Bulletin No: B106CRM156-0
 Release Date: April 8, 2008
 Effective Date: April 8, 2008
 Supersedes: N / A
 Completion Date: June 8, 2008
 Page: 1 of 2

SERVICE BULLETIN

Ride Name: ZIPPER Affected Serial Nos.: All

Abstract of Issue:
 Safe Rider Instructions

**Rider Safety Instruction Sign
(part number 1060181-001)**

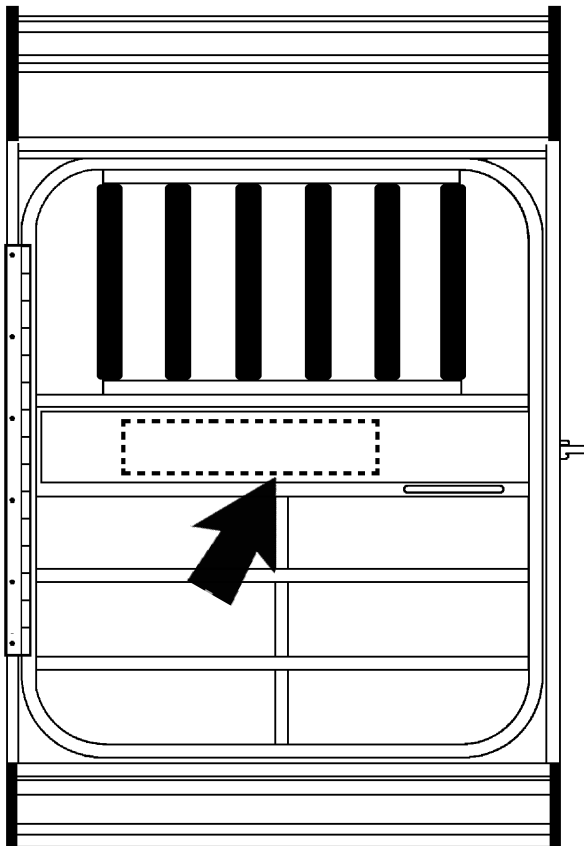
Chance Rides Manufacturing, Inc. has developed a safety sign to remind passengers of the importance of being properly seated. One sign must be mounted to the door frame on the inside of each vehicle so that it can be read by passengers while they are seated in the ride. (See illustration on following page.)

Install on INSIDE of door frame crossmembers as shown.

1. Locate the sign as shown, then transfer the mounting holes to the door frame.
2. Drill 6 holes, 1/8" diameter, through one side of the steel tube.
3. Install the sign using the rivets provided.
